REMARKS

It is noted that the corrected or substitute drawings, submitted on June 20, 2003, have not been approved because they purportedly do not overcome all of the previous objections and do not comply with revised amendment practice as recently promulgated. Initially, it is noted that the revised amendment practice has been made effective as of July 30, 2003, which is subsequent to the date of filing the drawings. Nevertheless, the Examiner's point as regards determination of changes is well taken, and hence a marked-up copy of the drawings as originally submitted, supplemented by changes presented herein in response to the September 8, 2003 office action, accompany herewith.

Figure 1D

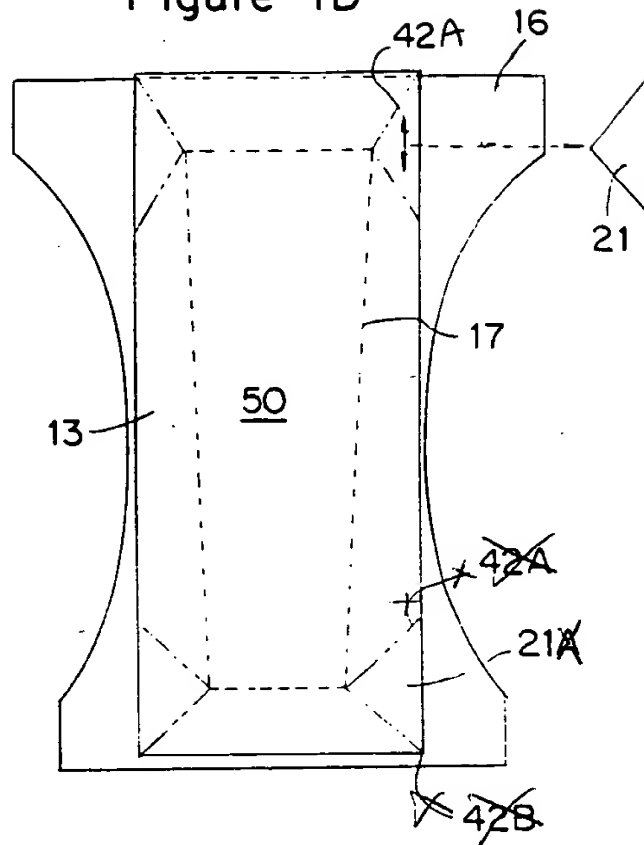
The last sentence of the insert to page 8 is said to be unclear because an arrow is described whereas Figure 1D shows an arrow having two arrowheads. This issue is inconsequential, but amended in the specification to the Examiner's preference. Figure 1D is revised to change "21A" to "21", and in Figure 1F, numeral 21 is deleted, to avoid possible confusion.

5) Description in the text and drawings with respect to numerals 42, 21, 21A, 42A and 42B are said to be inconsistent. In response, amended are inserts at pages 7 and 8, as well as drawing corrections at Figures 1D-1F, for consistency.

Figure 2

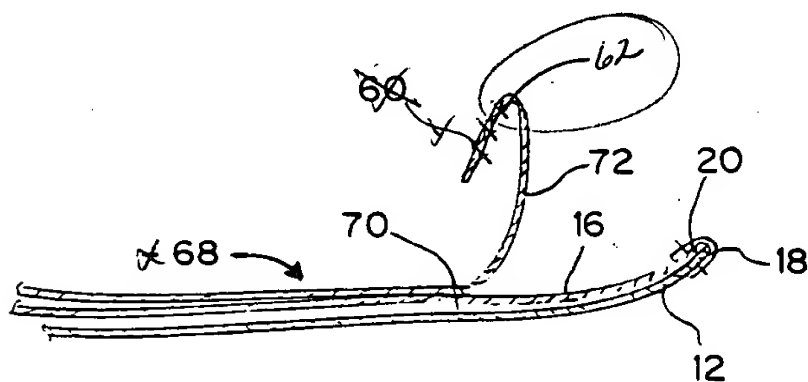
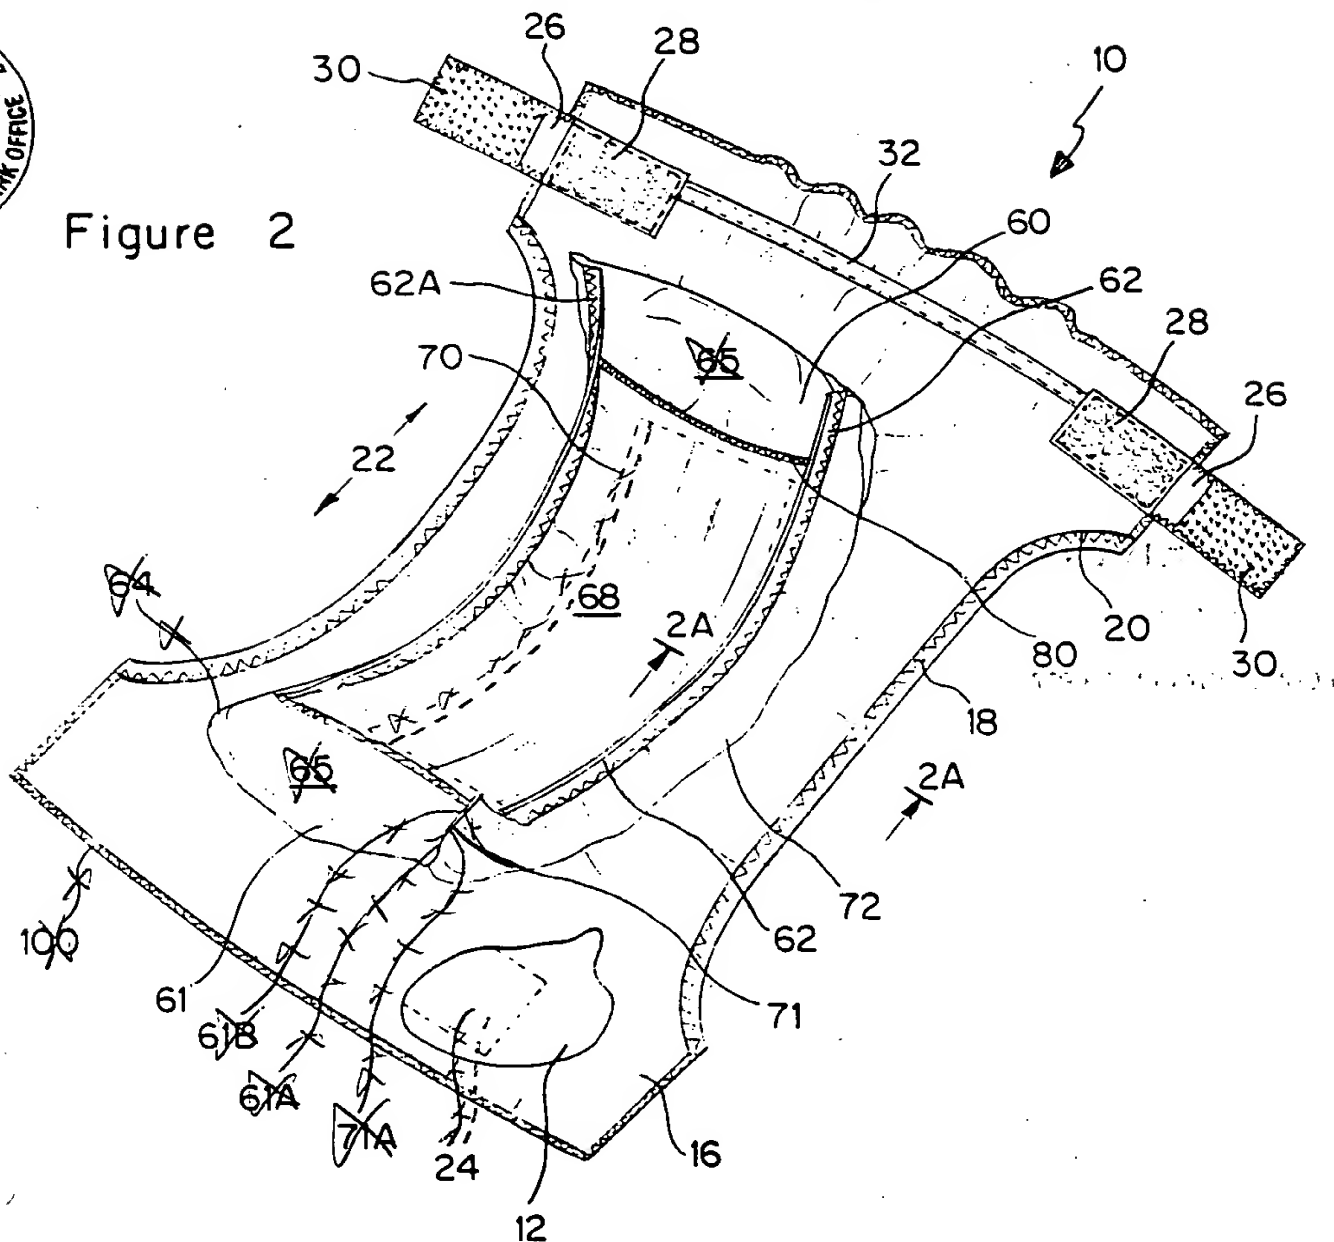
The Examiner asserts that Figure 2 appears to define an intermediate step of construction, inconsistent with the description of Figure 2 on page 4. The description of Figure 2 on page 4 has been amended, for consistency.

The Examiner questions where in Figure 2 is the structure as set forth in the first paragraph on page 10, last sentence thereof. Page 10 is amended herein for better clarity.

The Examiner also complains of difference in configuration of stitching 70 in Figures 2C-2E versus that shown in Figure 2. This is to be expected, however, as in Figure 2, the pocketed sling 68 is bowed, whereas in other Figures the sling is planar. No correction is necessary.

Figure 4

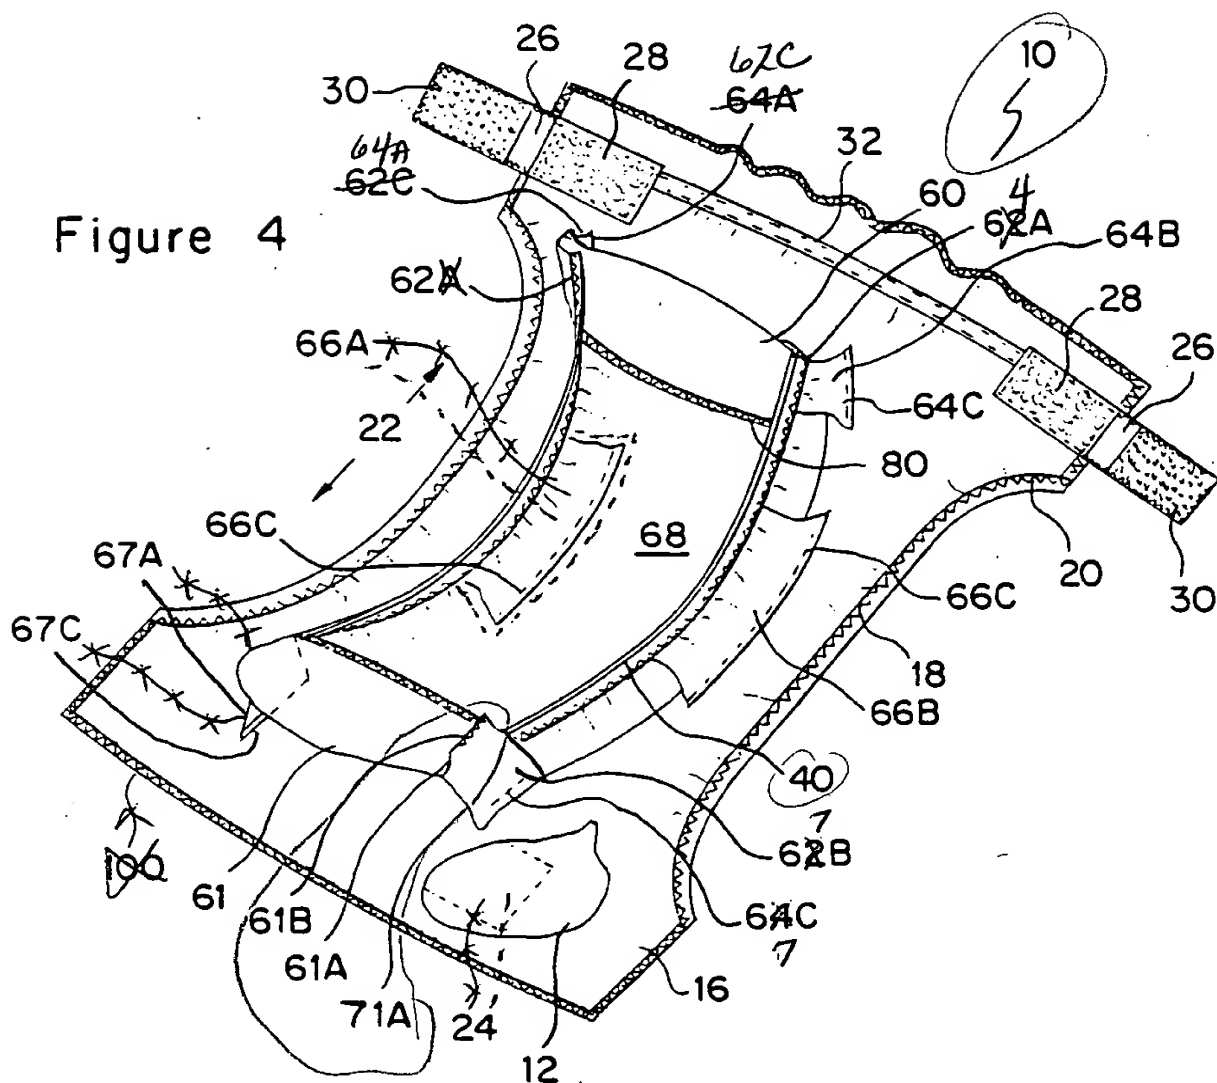
The Examiner notes that Figure 4 is deficient in that element 66A is shown as being inside the pocket (whereas it is outside), and several items are mislabeled. Corrections in this respect are made to Figure 4, with element 66A now presented in dashed lines, lead lines corrected for element 67A and 67C and specified reference numerals corrected.

Figure 6

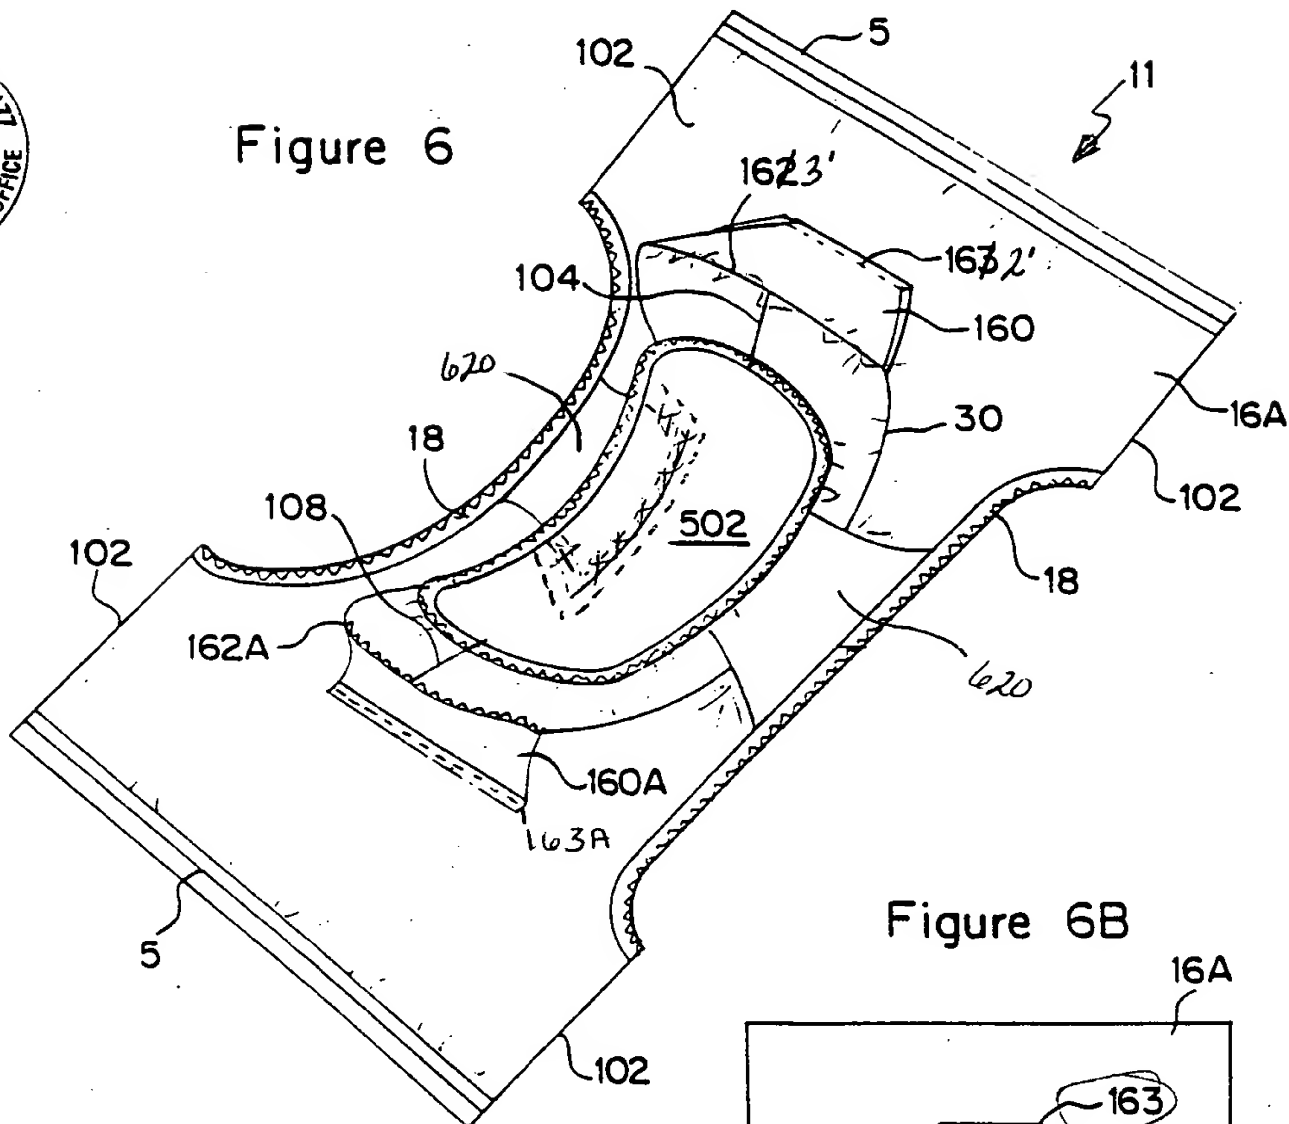
Strip 620, mistakenly depicted as being within pocket 502, has been corrected in the drawing. Element 163', corrected to 162' and element 163A are depicted in Figure 6.

9) The Examiner notes inconsistency of the description at page 12, line 11 – page 14, line 15, and Figures 5-6B. Figure 6 is amended, to address inconsistency. The Examiner questions where sides are bent and joined at a seam in Figure 5A. Bending and joining is initiated in Figure 5A, but appears in completed form in Figure 5B. However, it is reiterated that the subject matter of Figure 5 is not elected, nor under substantive examination.

Figure 6A

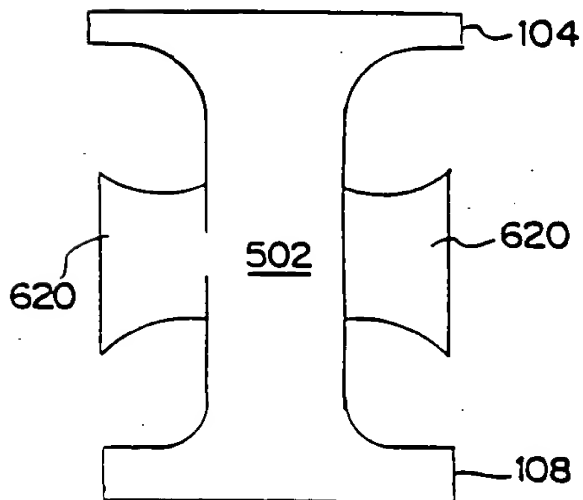
The Examiner questions where in Figure 6A is the structure as set forth on page 14, lines 12-13. The Examiner also notes pocket elastic as being described as both 400A and 40 and shown as 400A. Element 620A is questioned also. The specification is amended to address these concerns.

Figure 7

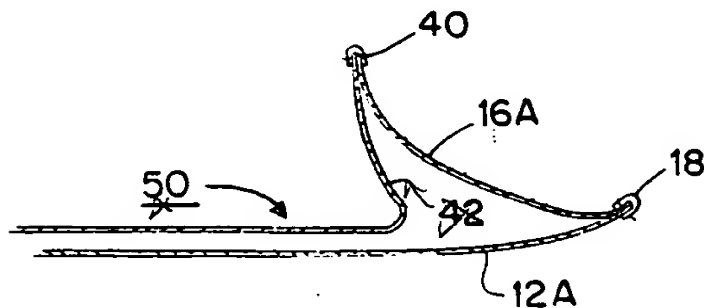
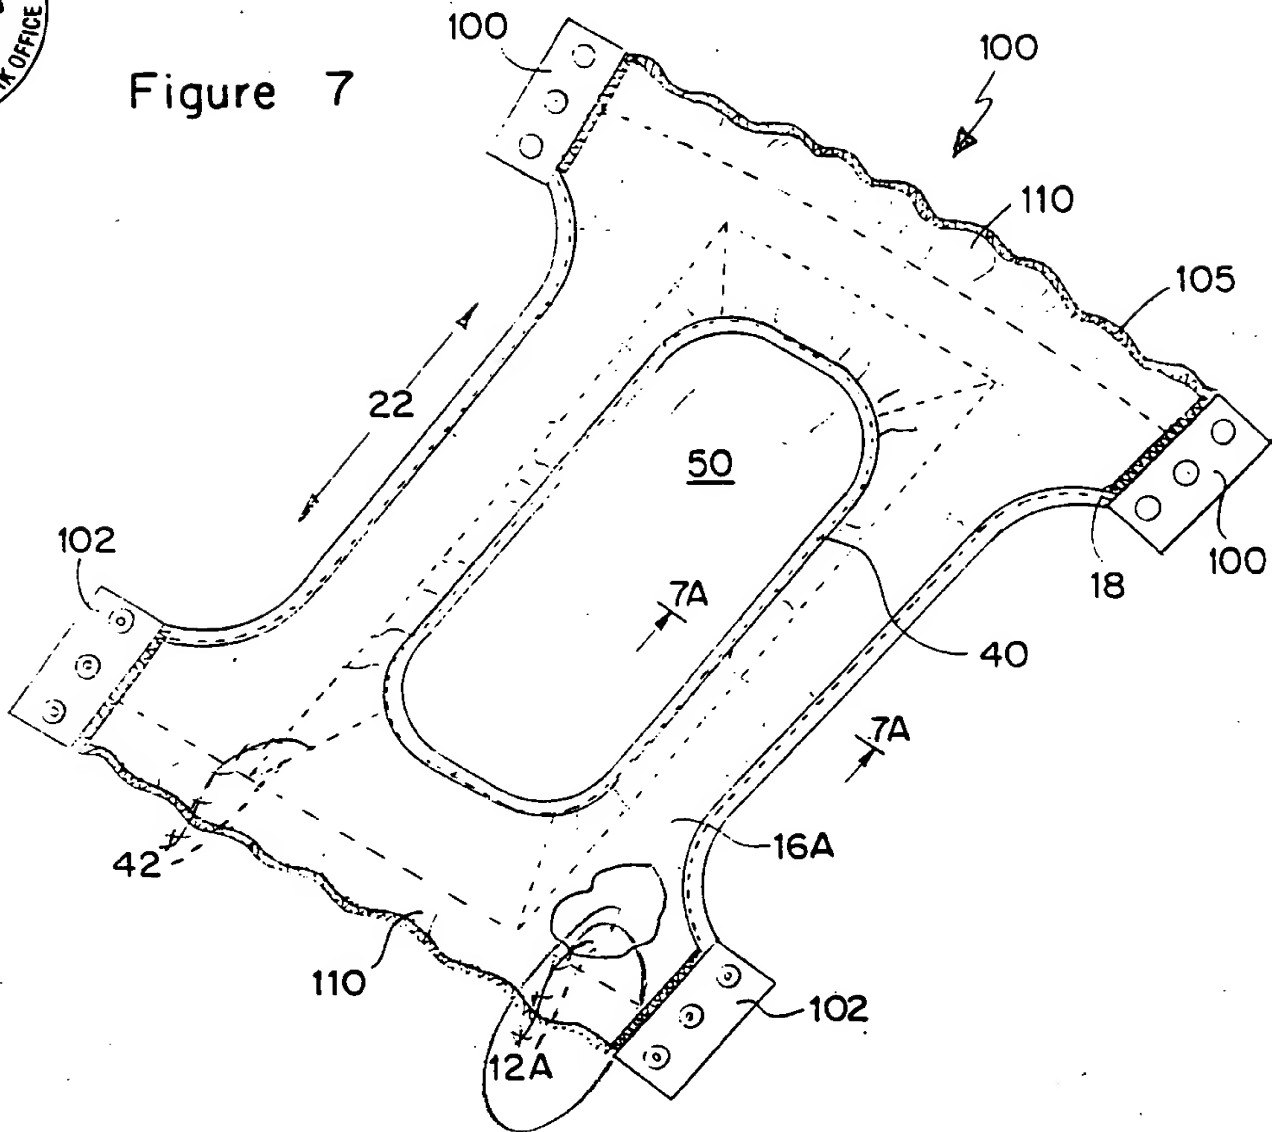
The Examiner questions where 43 is shown, but it is not apparent where 43 is described in the specification. The numeral 102 has been added to the description of Figure 7.
